D/DRC Case

1731 Heyward Street

**DESIGN/DEVELOPMENT REVIEW COMMISSION
DESIGN REVIEW DISTRICT
HISTORIC AGENDA
EVALUATION SHEET
Case #2**

NATURE OF REQUEST: Request Certificate of Design Approval for exterior changes and preliminary certification for the Bailey Bill.

Main Floor Plan

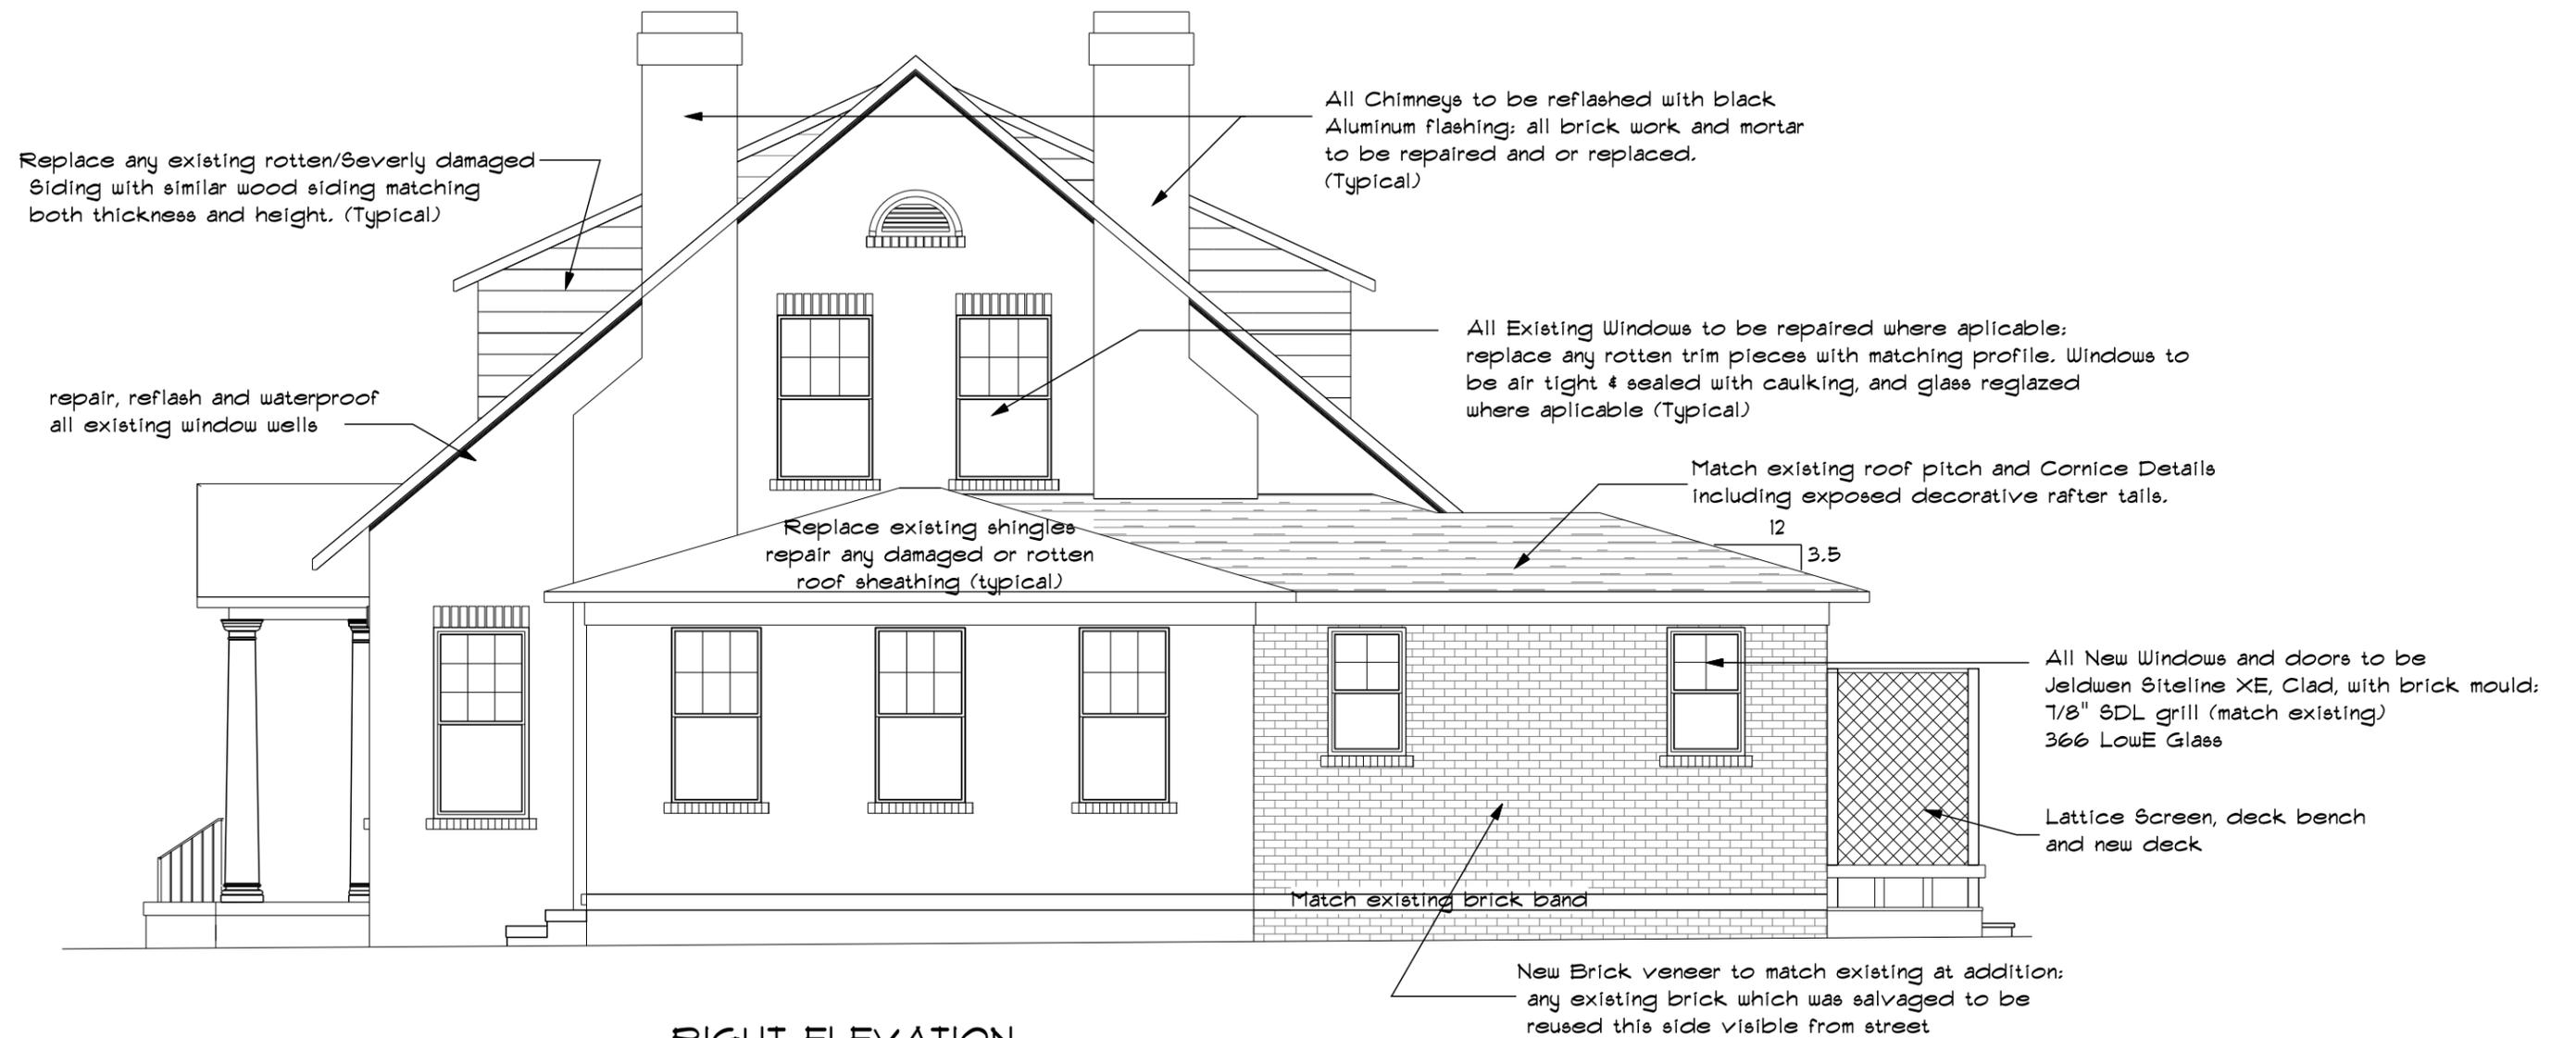
A small 1-story master bath addition is proposed for the right rear corner of the house. Its size and placement will make it minimally visible from the public right-of-way, and it will not detract or obstruct important architectural features. As proposed, the rear addition is brick that will match existing, and is stepped in to differentiate the new addition from the historic portion of the house.

The addition will feature materials and detailing compatible with the original portion of the house. The new roof will match the existing roof pitch and the cornice details of the original house including the exposed decorative rafter tails will be replicated on the addition. The new brick veneer proposed for the addition will match the historic brickwork as closely as possible in material type, size, shape, mortar composition, consistency, color and tooling.

RIGHT ELEVATION

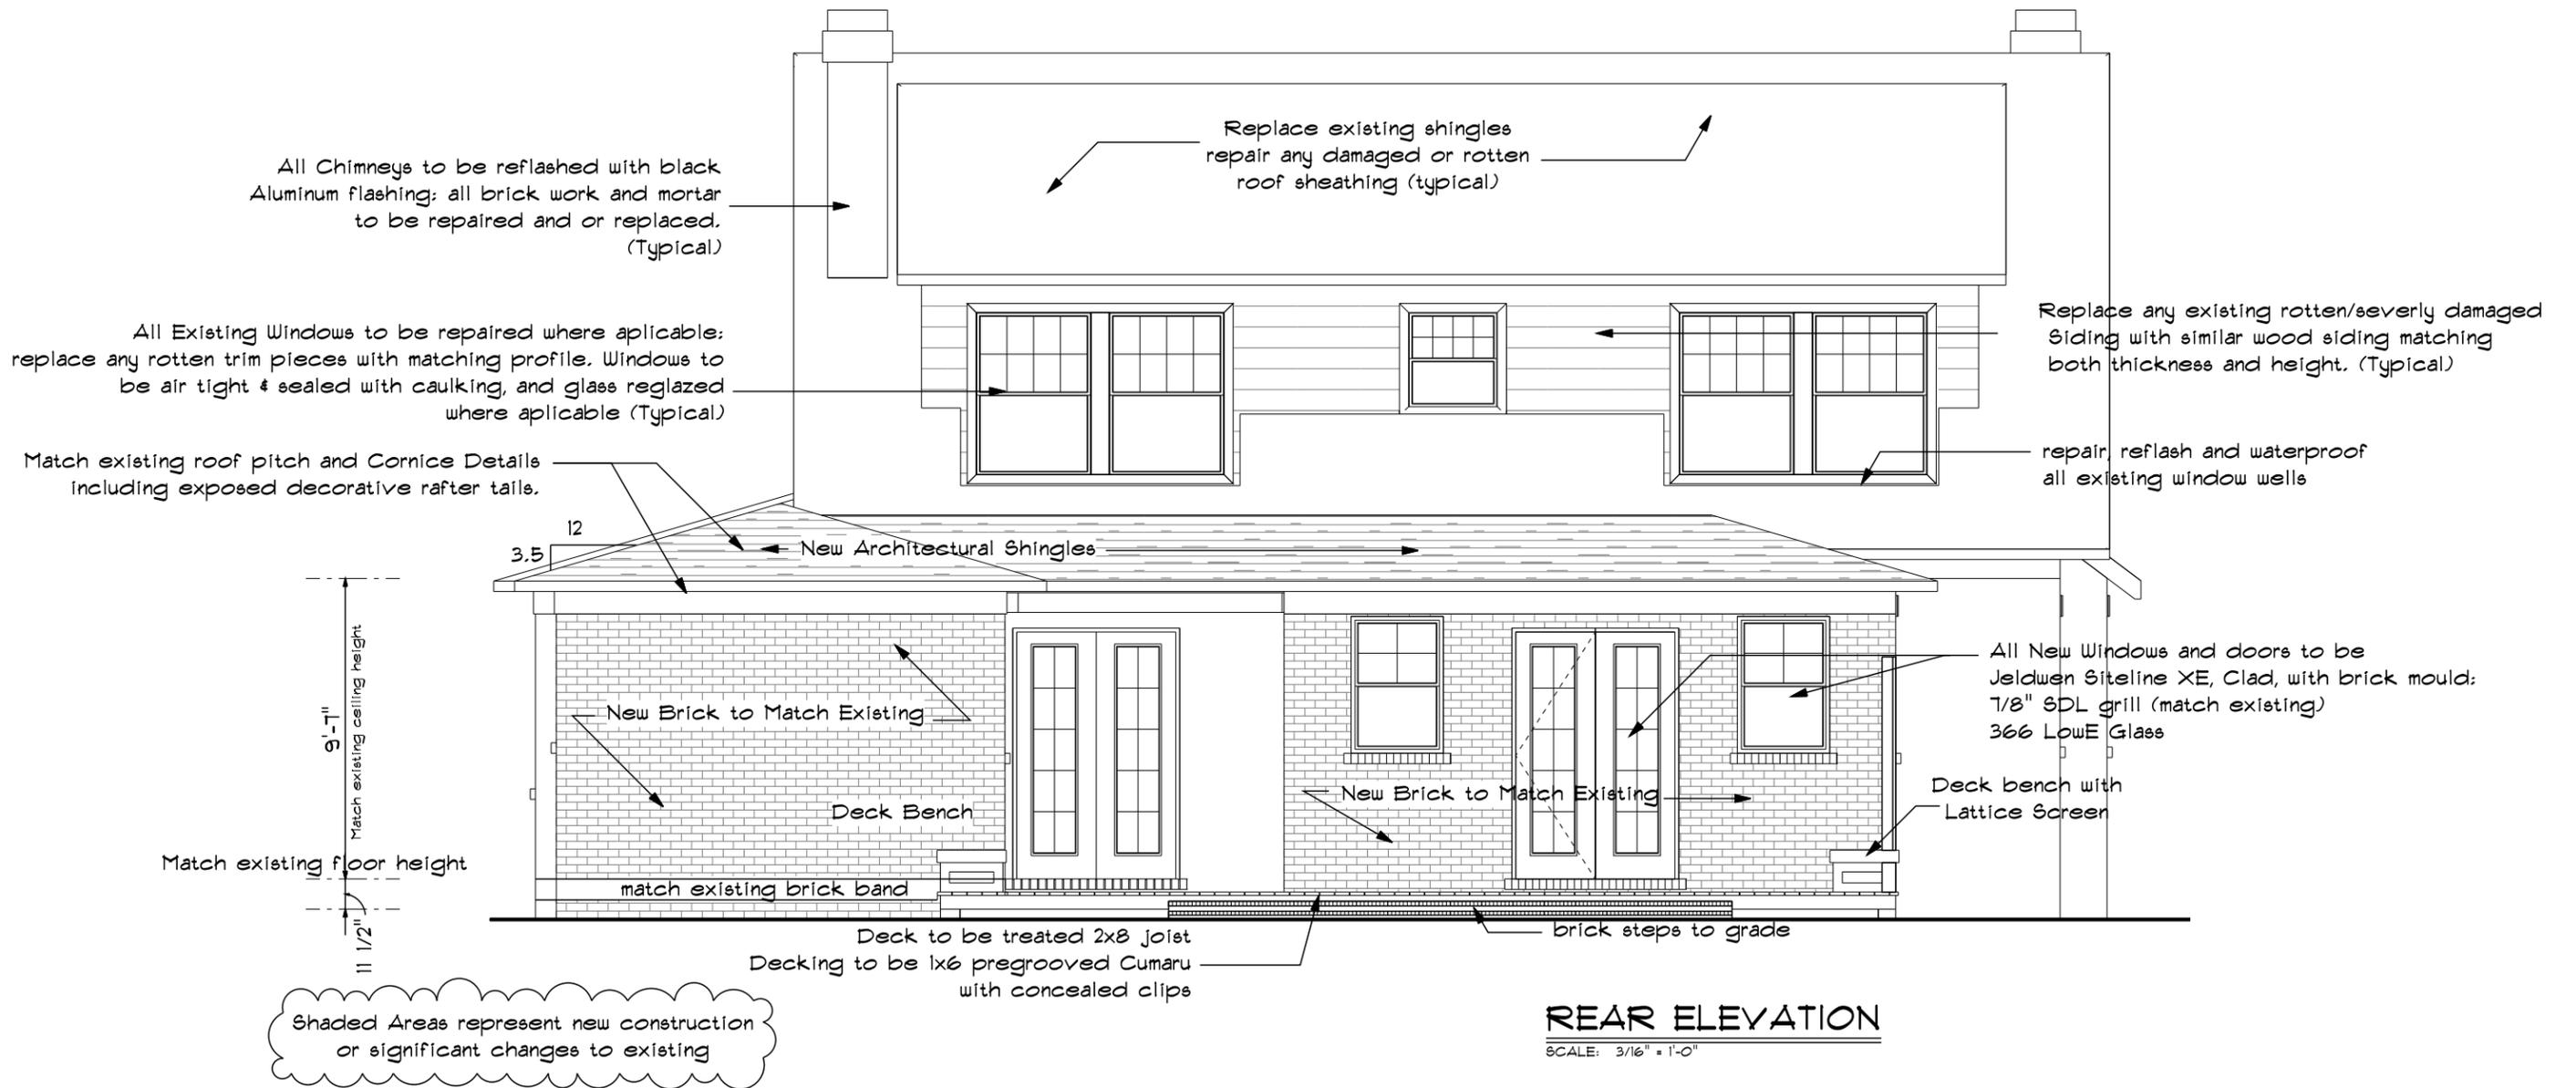
The proposed aluminum-clad SDL windows on the visible portion (right side) of the addition are much smaller and feature a different pane configuration than the original windows. The width of the SDL grids for the proposed windows is 7/8" which is wider than the 5/8" muntins of the existing windows. Staff recommends making the size, pane configuration, and muntin width of the proposed windows consistent with

the existing windows. This would require 6/1 wood or aluminum clad windows with 5/8" muntins/grids. No plastic, vinyl, or PVC products will be used.

- *The two windows on the right side of the addition shall be 6/1 wood or aluminum-clad windows with 5/8" muntins/grids and shall be consistent with existing window sizes on the side wing.*
- *All details deferred to staff*

GARAGE FRONT ELEVATION

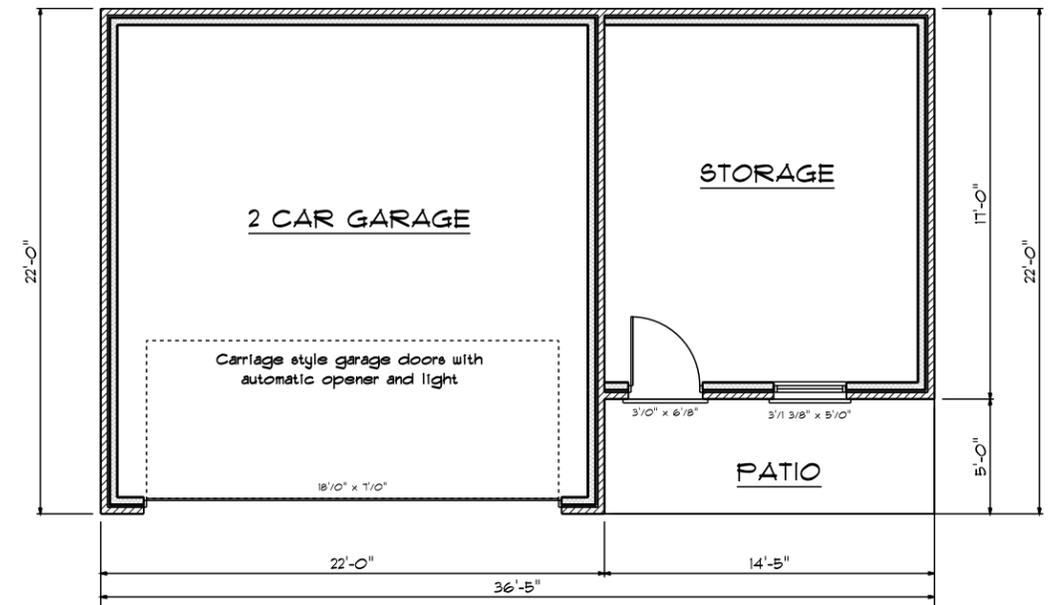
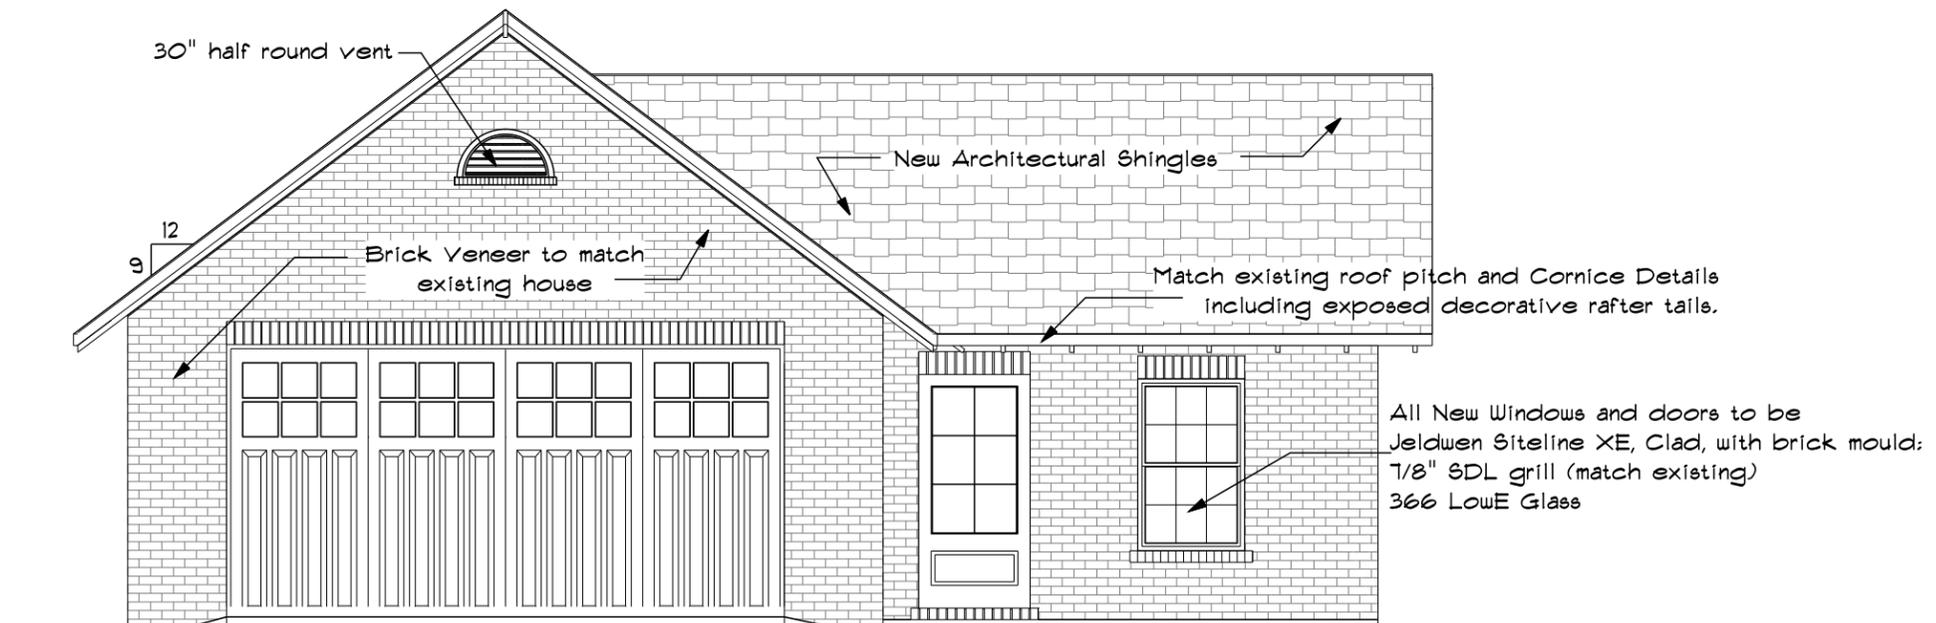
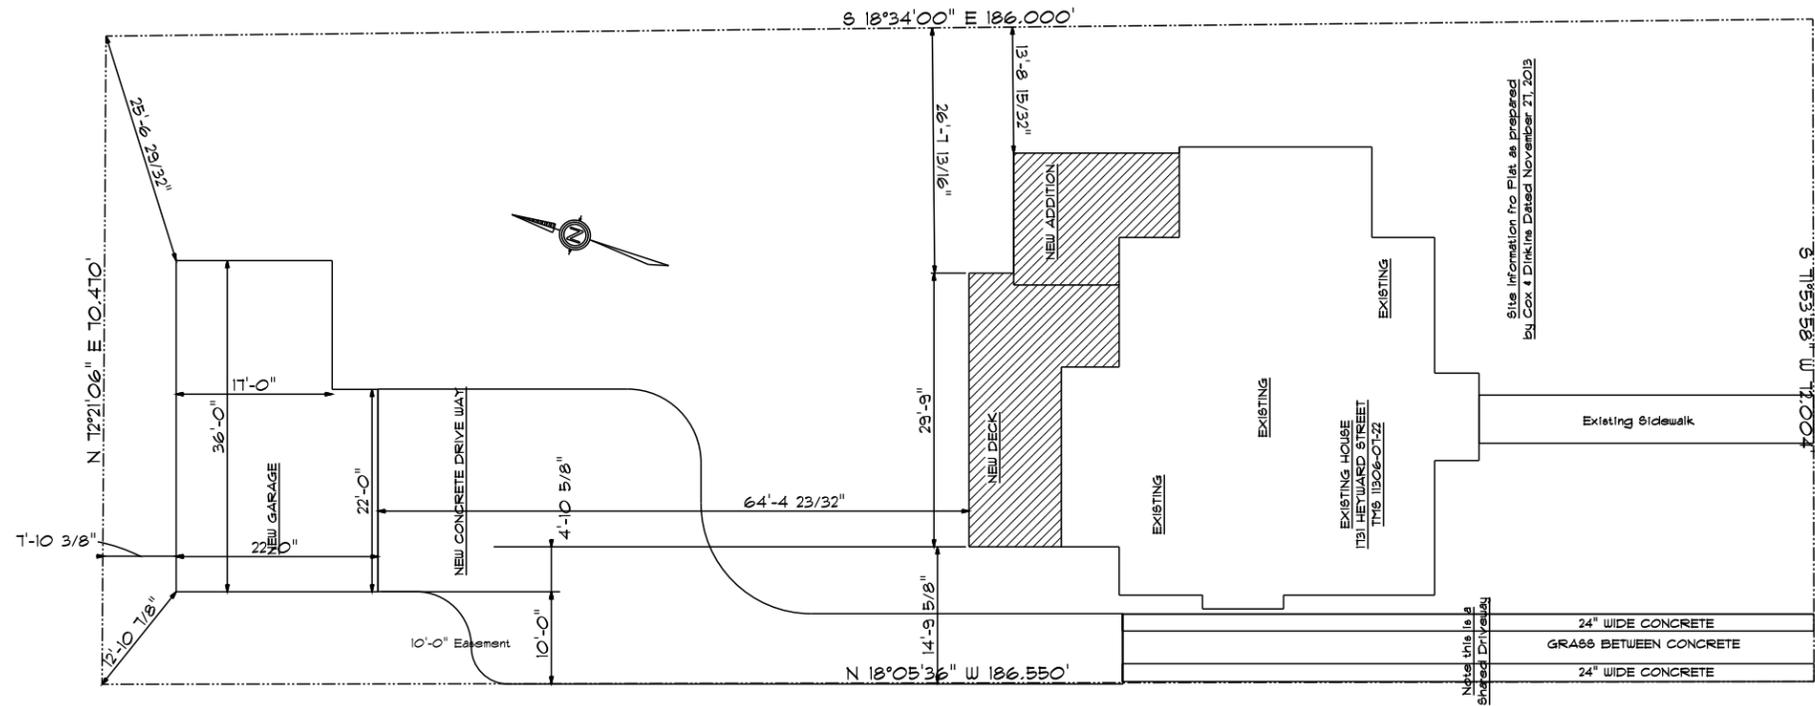
The new 1-story, two-car garage/storage building will be placed on the left rear of the parcel. It will be approximately 75' away from the rear of the house.

The new garage is a cross-gable design that utilizes brickwork and architectural details to promote consistency with the house. The roof pitch, cornice details, and exposed decorative rafter tails will match the existing house. The main portion of the garage features a front gable with a single opening large enough for two cars. The garage door features a carriage door design that makes the garage appear to have two bays. The right side of the garage features an inset storage room with a side gable roof and single entry door on the façade. A single window with a decorative brick lintel and sill is also on the façade.

The 1-story garage has a footprint of 22' x 36'5" and has massing that is subordinate to the primary 1 1/2 story structure.
